Agenda Item Name 0650 HAMILTON FORM-BASED CODE UPDATE ASSOC. WITH S LOGAN TOD

Hamilton Form-Based Code update to SMC Chapter 17C.123 for South Logan TOD Implementation to support transit-oriented development.

**CITY OF SPOKANE PLAN COMMISSION
FINDINGS OF FACT, CONCLUSIONS, AND RECOMMENDATIONS
REGARDING HAMILTON FORM-BASED CODE AMENDMENTS**

Figure 17C.123.40-A

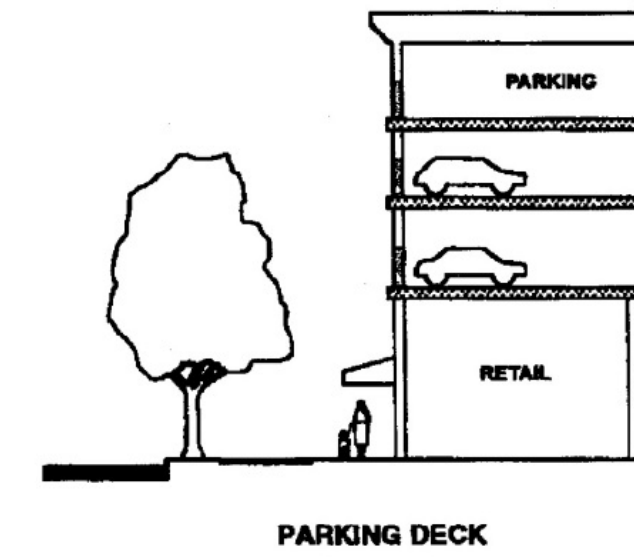
If fronting on a Shopfront designation, above-ground parking structures shall provide continuous ground level commercial or office spaces and uses along the street, except at ingress and egress points into the structure. (See Figure 17C.123.040-A).

Figure 17C.123.40-B

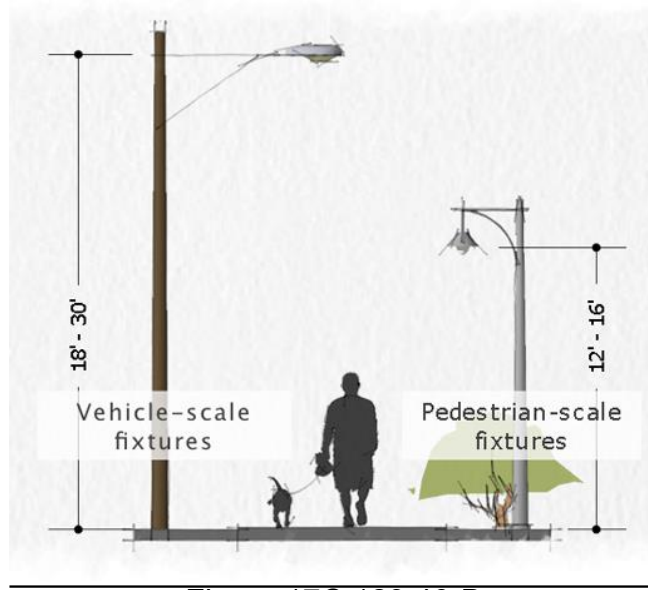
Pedestrian-scale fixtures shall be used for all lighting illuminating required Pedestrian Paths. Vehicle-scale fixtures may be used for general surface lot and site lighting. Lighting shall meet the dimensions of Figure 17C.123.40-B.

Figure 17C.123.050-A –
Desired Frontage Characteristics.

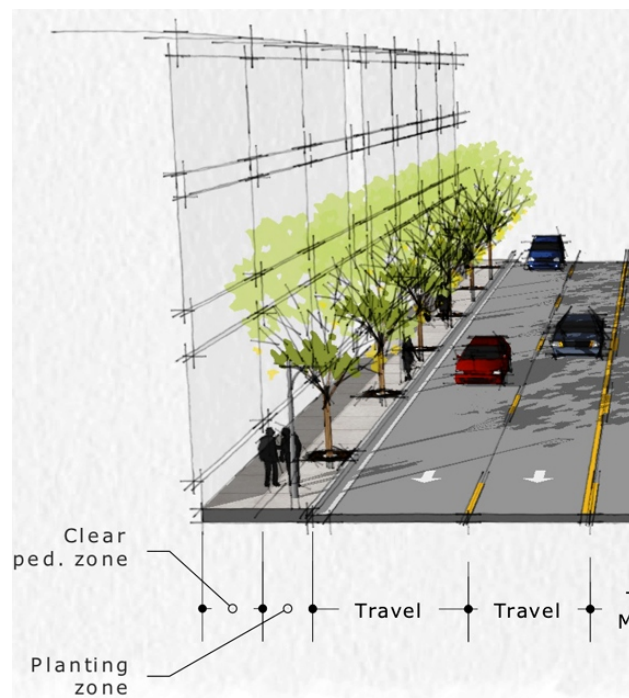
Type	4' x 2' scored concrete		N/A
Clear Pedestrian Zone	7 ft. [2]		N/A
Buffer Zone (each side) [3]	5 ft.		N/A
Street Furnishings			
Lighting, types [4]	P	P	V
Planting, types [5]	S	S/M	N/A
Benches [6] [7]	R	R	N/A
Trash receptacles [6] [7]	R	R	N/A
Bicycle parking [6] [7]	N/R	R	N/A
[1] See City of Spokane Department of Engineering Design Standards for additional specifications.			
[2] Along Columbus Street, a 10-foot wide Clear Pedestrian Zone is required.			
[3] A reduced width may be permitted with an approved alternative planting system, such as modular suspended pavement systems, with the approval of Urban Forestry.			
[4] "P" = Pedestrian scale; "V" = Vehicle scale			
[5] "S" = Street trees; "M" = Median planting			
[6] "R" = Required; "N/R" = Not required			
[7] Buildings less than 10,000 sf. are encouraged to include such amenities but are not required.

Figure 17C.123.060-A –
Illustration of building base, pedestrian scale signs and other building elements
described in the FBC.

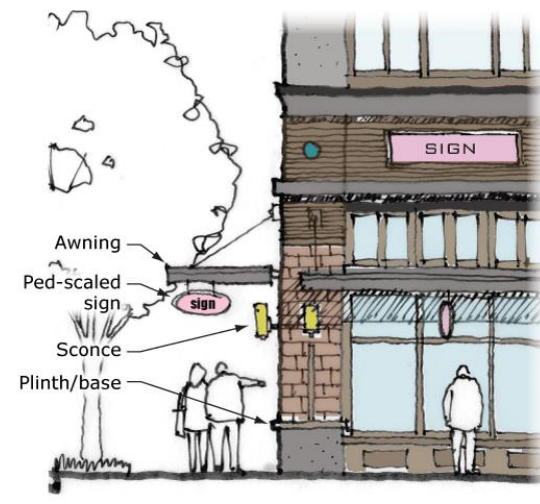
1. A horizontal projection of at least 3 inches that may be accompanied by a change of material and/or color.
2. A horizontal architectural line or feature, such as a belt course or secondary cornice, at or below the top of the first story and providing visual separation between the first two floors (See Figure 17C.123.060-A).

Figure 17C.123.060-B –

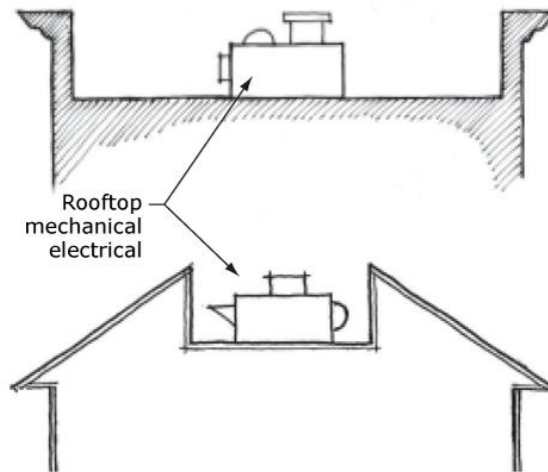
1. Rooftop mechanical and electrical equipment shall be screened their full height by a parapet wall, enclosed within roof volumes or other building elements designed as an integral part of the building's architecture.
2. Ground-level mechanical and electrical equipment shall be enclosed within secondary building elements or screened by features designed to coordinate with the architecture of the primary structure. Year-round vegetative screening the height of the equipment at planting is permitted. Picket or chain-link fencing may not be used (See Figure 17C.123.060-B).
